GOLD STANDARD VERIFICATION REPORT

For: CO2 Balance

REPORT NO.: GS3105-08;3560-61VER06-07

GHG related activity	Verification
Project Title (s)	GS1247 VPA 24 Improved Kitchen Regimes - Dowa Boreholes, Malawi GS1247 VPA 25 Improved Kitchen Regimes - Dowa Boreholes, Malawi GS1247 VPA 26 Improved Kitchen Regimes - Kasungu Boreholes, Malawi GS1247 VPA 27 Improved Kitchen Regimes - Kasungu Boreholes, Malawi GS1247 VPA 36 Improved Kitchen Regimes - Dowa Boreholes, Malawi GS1247 VPA 37 Improved Kitchen Regimes - Dowa Boreholes, Malawi
Project ID (s) (i.e.: GS-ID)	GS3105 – VPA 24 GS3106 – VPA 25 GS3107 – VPA 26 GS3108 – VPA 27 GS3560 – VPA 36 GS3561 – VPA 37
GS Project Type	Cookstove
PoA Title (if applicable)	GS1247 Improved Kitchen Regimes Multi-Country PoA
POA ID (if applicable)	GS1247
Responsible Party	Sustain Cert S.A.

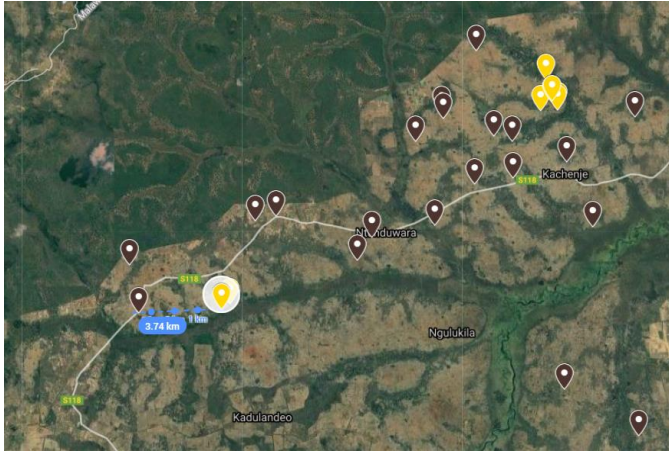
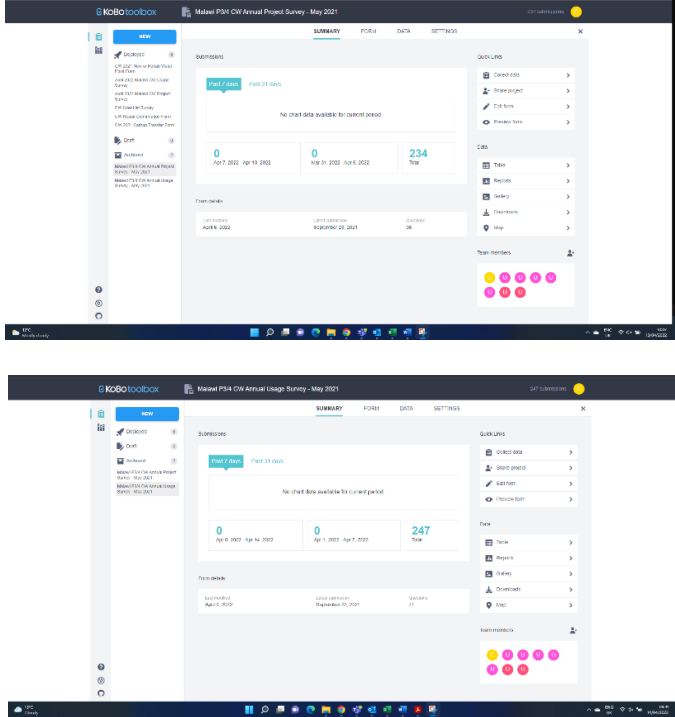
Rule	Assessment Question	Findings/Comments	Developer Response
	Are any forward actions declared correctly and addressed?	CL#5: Section B.1.1: The following FARs were not addressed in the MR: - Forward Action Request # 1: The PP shall demonstrate the compliance to the required conditions in the Annex 3 of the methodology "Application of the methodology to safe water supply project". E.g. The water in its improved form should be available within 1 km walking / pedalling distance from the households - Forward Action Request # 2: PD should note that GS-TAC has determined parameter caps during an ongoing grievance as follows: Firewood consumption to boil 1 litre of water for 10 minutes will be capped at 0.400 kg for three stone firewood baseline stove scenarios. For other baseline fuels, projects will be assessed on case-by-case basis. AND For borehole projects, the number of users per borehole will be capped based on specifications	FARs added to table in MR section B.1.1 - Household lists were analysed and only users within 1km of the borehole were considered as part of the ER calculations - A cap of 0.4kg/l (0.0004 t/l) has been applied to all ER calculations, as well as a cap of 300 users per borehole - MR has been updated to include requested data

Rule	Assessment Question	Findings/Comments	Developer Response
		from the borehole technology supplier/manufacturer. Depending on the outcomes of the grievance process, there is a potential for corrective measure, including but not limited to GS rule update and possible remedies for existing GS projects. Please see the grievance ToRs for more detail on how remedies may be proposed and applied. ○ Forward Action Request # 3: For the next verification, PD shall provide full transparency on maintenance programme roles and responsibilities. This should include: the process of recording and reporting all faults/breakdowns and when a technology starts working again. It should also include a summary of all planned annual maintenance tasks and the downtime expected for these tasks. Monitoring reports must have % total borehole downtime (and days) recorded transparently in Project Technology Days parameter box. Not claim a whole day crediting on the day when a technology is repaired (some downtime is expected that day).

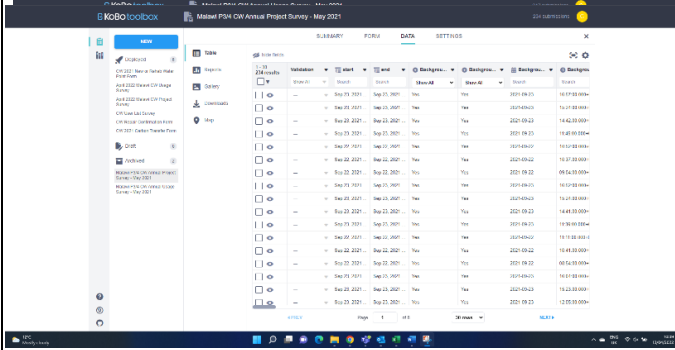
Rule	Assessment Question	Findings/Comments	Developer Response
	Does the monitoring system and the monitoring plan match the Design Certified VPA-DD?	CL#6: Section C: • Usage survey: The PP is requested to clarify why many of the interviewed people could be	The survey does not necessarily take place at the individuals dwelling, sometimes it may take place at work, whilst farming, or during other times individuals

Rule	Assessment Question	Findings/Comments	Developer Response
		considered as users to the project technology while their distance to the nearest borehole is more than 3 km as below:  The PP is requested to submit the example screenshots from the web application of the monitoring survey records as well as the Dashboard overview of all the surveys.	are not at home. An amendment has been made to the survey and the survey location will be included in the next PS and US. Example screenshots below  Total number of surveys is higher than the 120 sampled households as it includes surveys from phase 3&4. This is due to the survey method transitioning to Kobo.

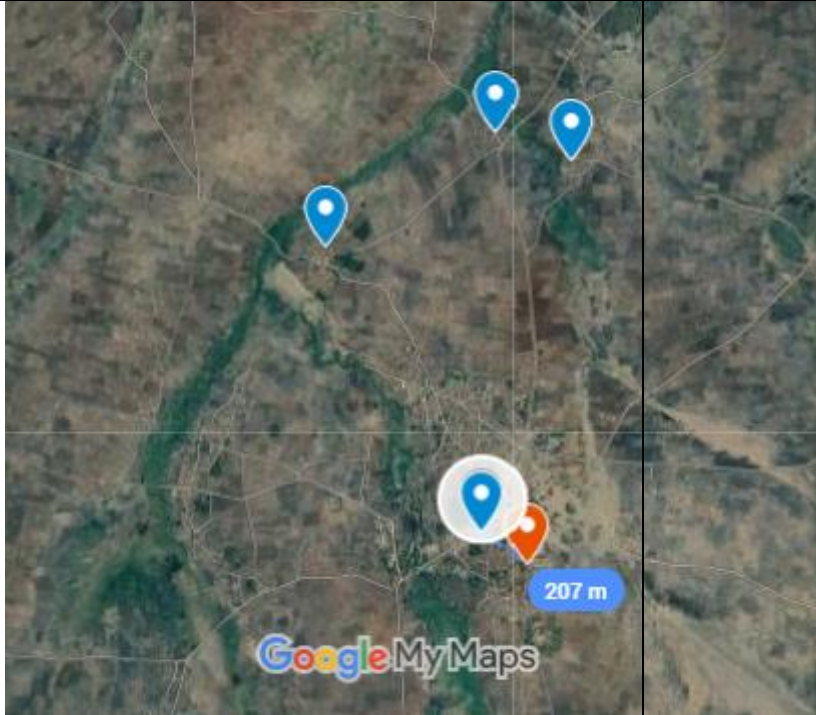
Rule	Assessment Question	Findings/Comments	Developer Response
P&R	For other SDGs, do the fixed ex ante values match the Design Certified VPA-DD	CAR#8: Section D.1: The value for parameter Tb,y does not match the Design Certified VPA-DD	Tb,y value in MR matches result from Revalidated baseline survey. Besides a value of 0.0177 (1.7%) is more conservative than 0.02 (2%) and the value reported in the VPA-DD may be due to rounding.
	Rd 2	The comment/request is open. PD shall correct the description.	MR Updated.

Rule	Assessment Question	Findings/Comments	Developer Response
		The comment/request is closed.
